Town of Breckenridge
Planning Commission Agenda
Tuesday, April 7, 2009
Breckenridge Council Chambers
150 Ski Hill Road

Planning Commission Staff Report

Planning Commission Staff Report

Project: Silverthorne House Site Plan
 PC# 2007004
 Date: 04/01/2009
 Staff: Julia Puester

Detail Sheet "1"

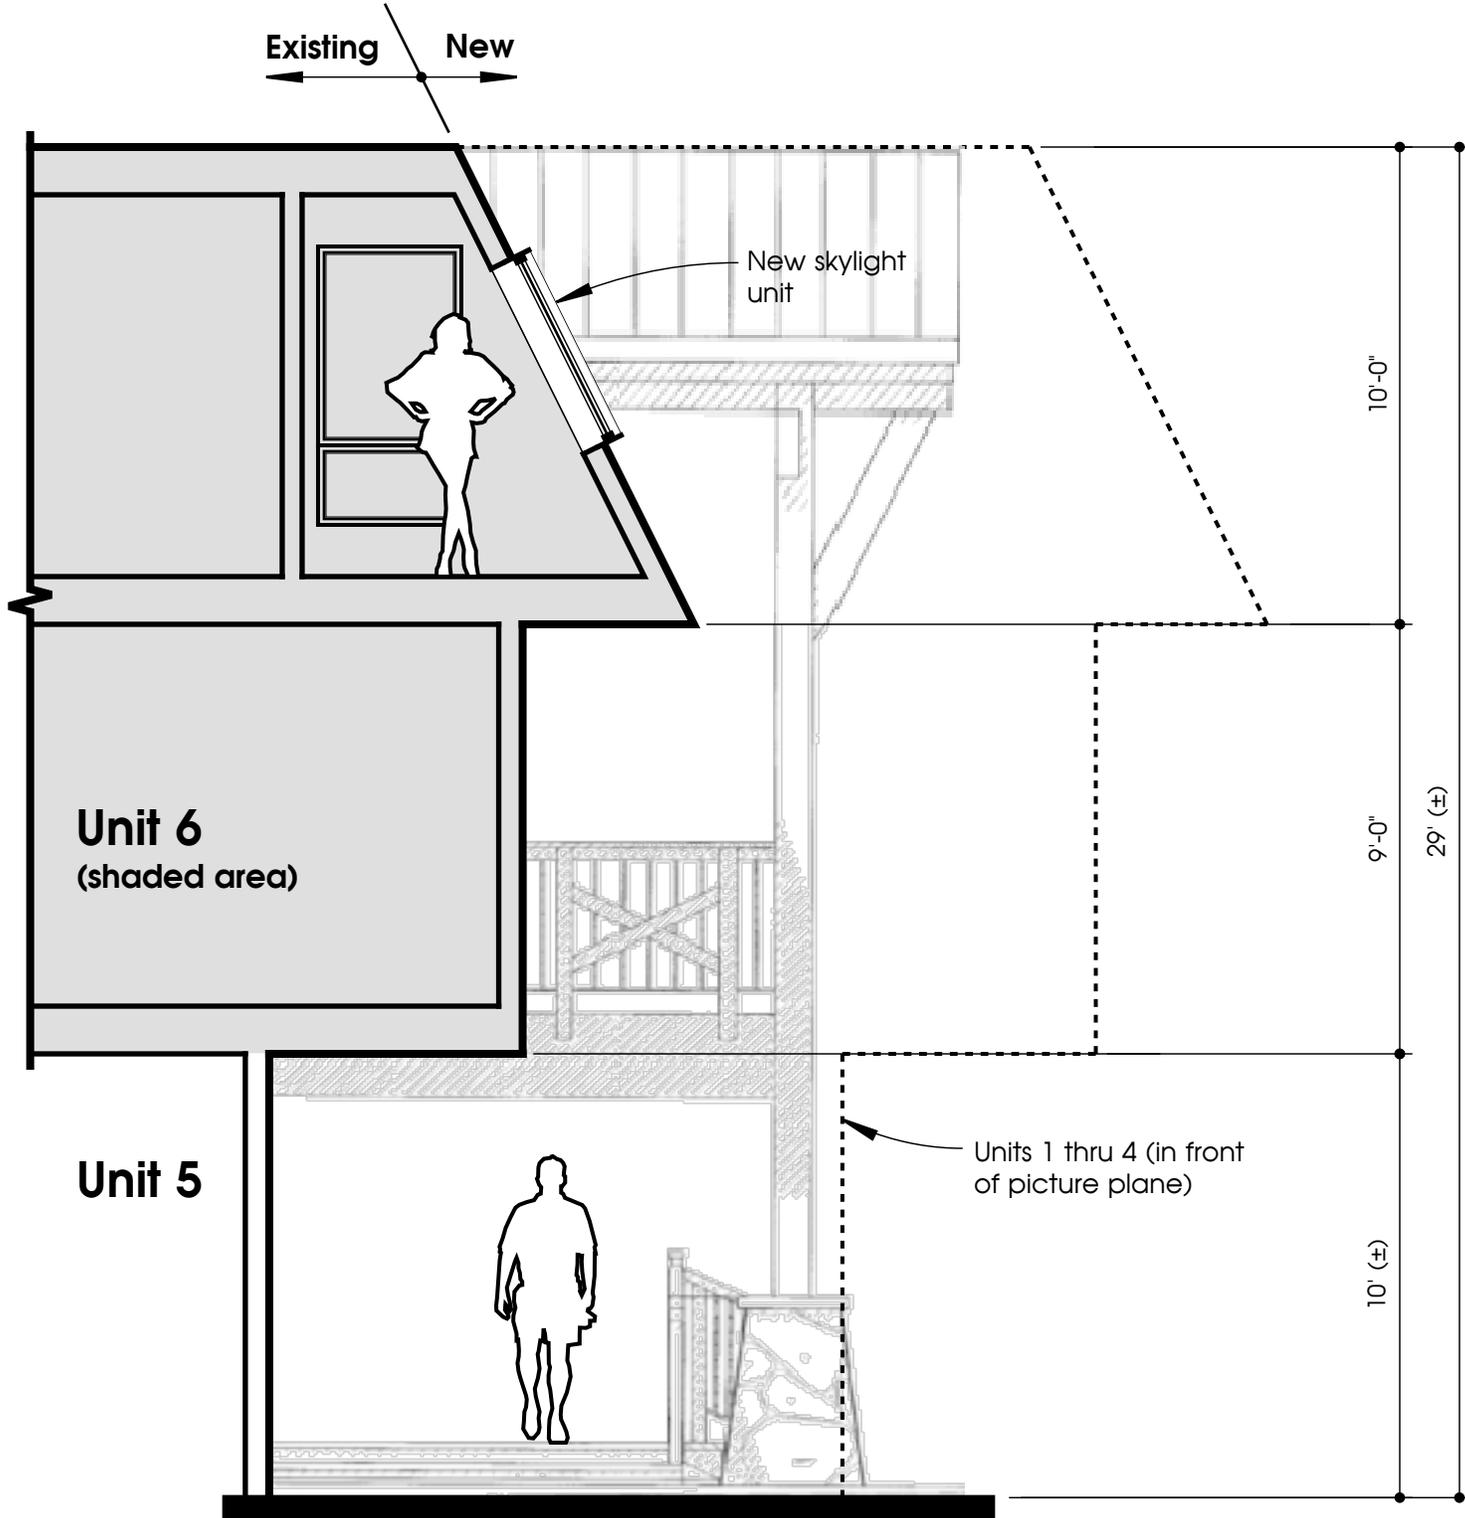
Architectural Compatibility (5/A & 5/R): The proposed skylights were not staff’s preferred way to address the applicants’ concern about lighting in the small bedroom of the unit. However, after reviewing the application staff has determined that the skylights are more architecturally compatible than was the proposed dormer. Accordingly, the staff has found that the modified application meets policy 5/A. The proposed addition of three skylights for unit 6 of Miner’s Candle Condominiums is architecturally compatible with the existing building, land use district and surrounding residential structures. The proposed addition of three skylights will have a minimal impact to the overall appearance of the building. To ensure the proposed three skylights blend as much as possible with the existing building, staff is requiring the skylights be ones that are tinted in a grey color to match as close as possible the existing roofing and has added a condition of approval stating such.

RIDGE ST. DEVELOPMENTS: LOT 5 MCADOO

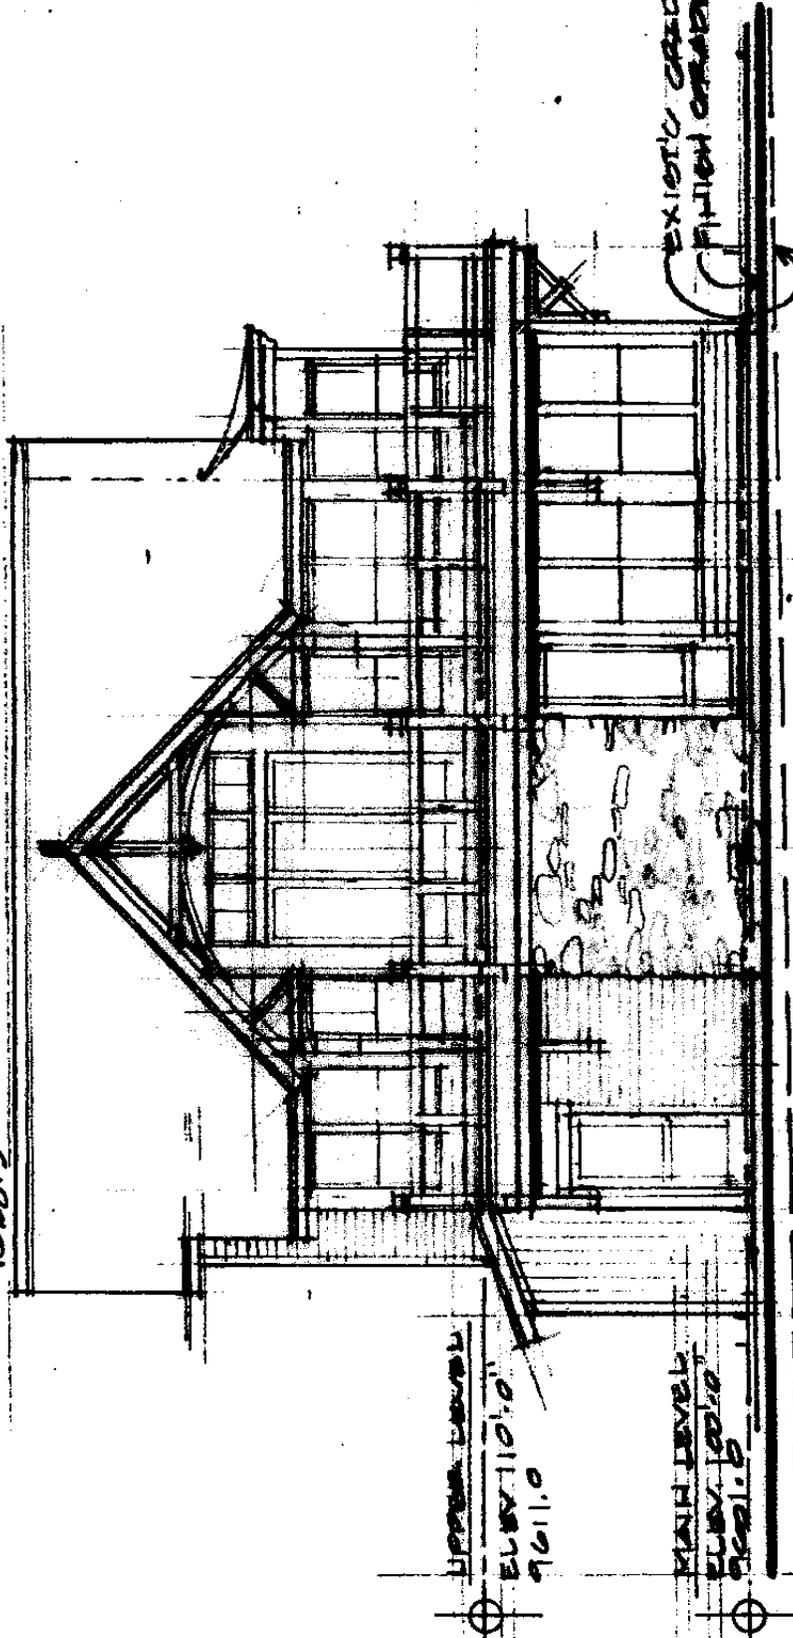
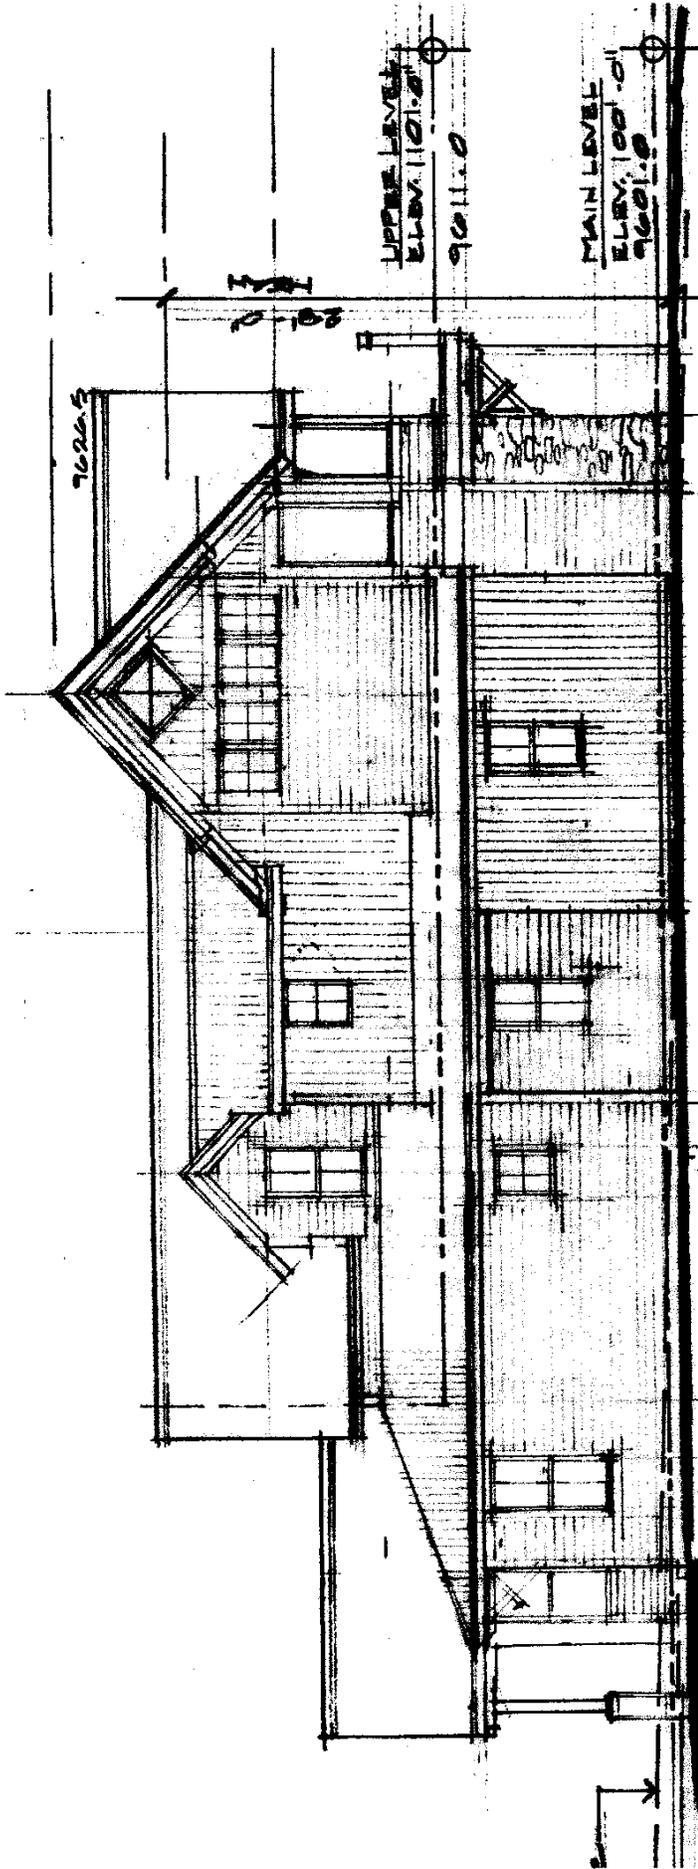
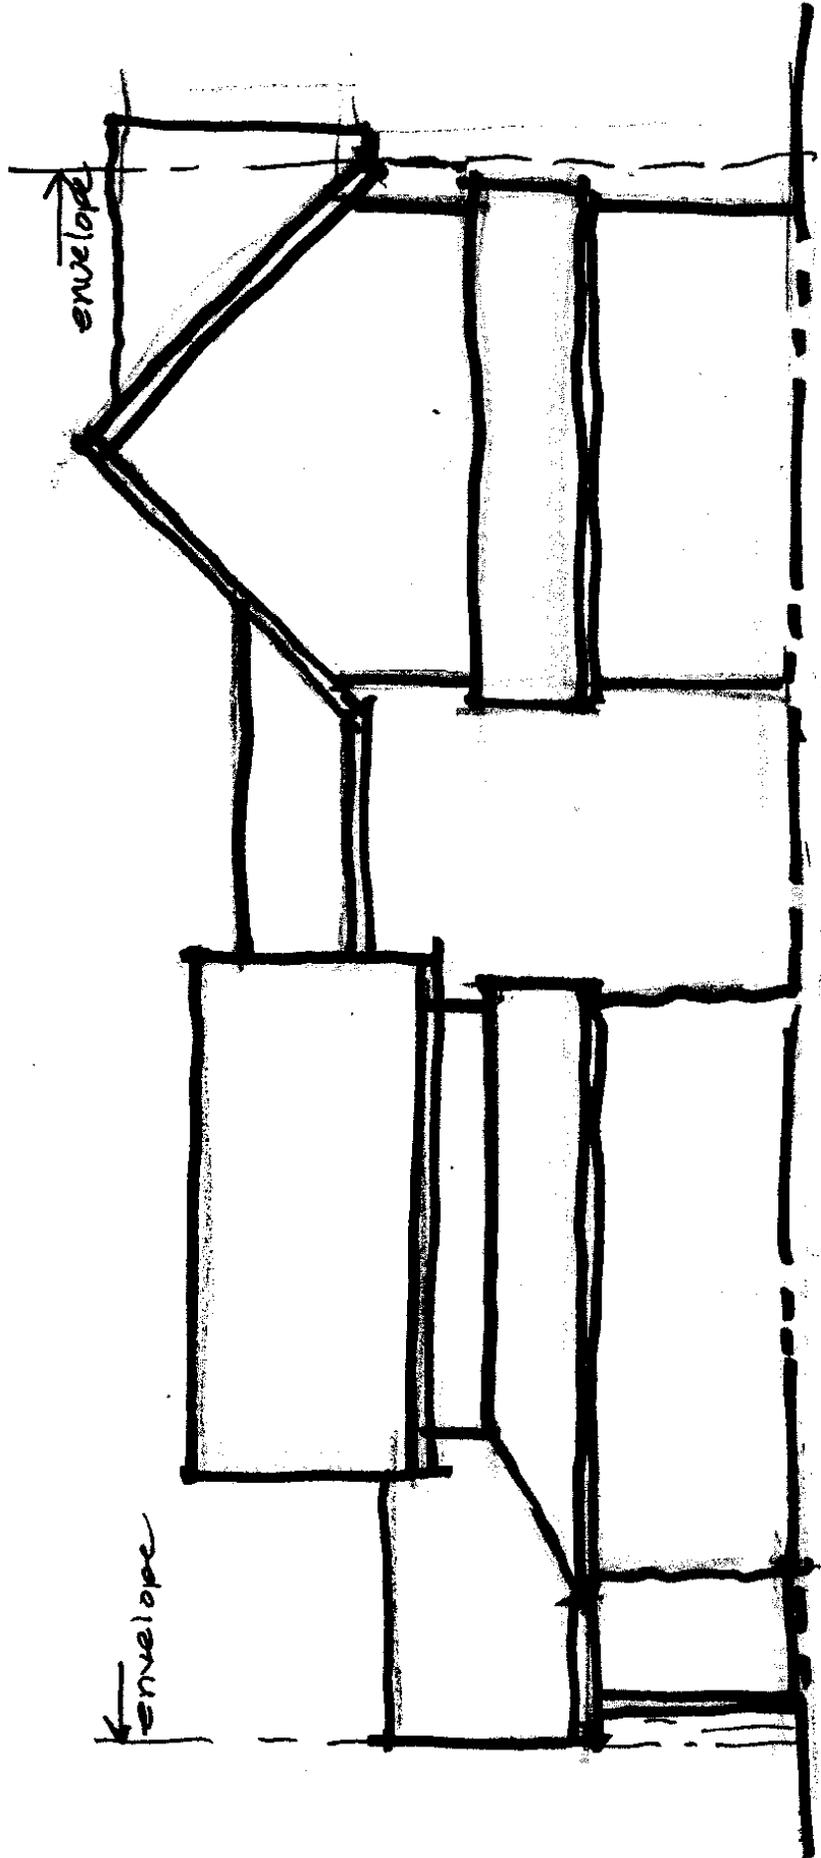
As the Commission read above, Staff does have concerns that the rear module size and the overall scale of this project. Does the Planning Commission agree with how Staff is measuring the module sizes? Does the Commission believe that Priority Policy 158 is being met?

Staff does not believe that Priority Policy 164 is being met. The front façade appears to be 37' in width. The priority policy states the front façade may not exceed 30'. Does the Planning Commission believe Priority Policy 164 is being met?

1. Does the Planning Commission find that the application meets the criteria required to exceed 9UPA (Priority Policy 158).
2. Does the Planning Commission believe that Priority Policy 80A (use of modules and connector width) is being met?
3. Does the Planning Commission find that the building height is similar to nearby historic buildings as required by Priority Policy 163?
4. Does the Commission find that the application meets Priority Policy 164 related to façade width?
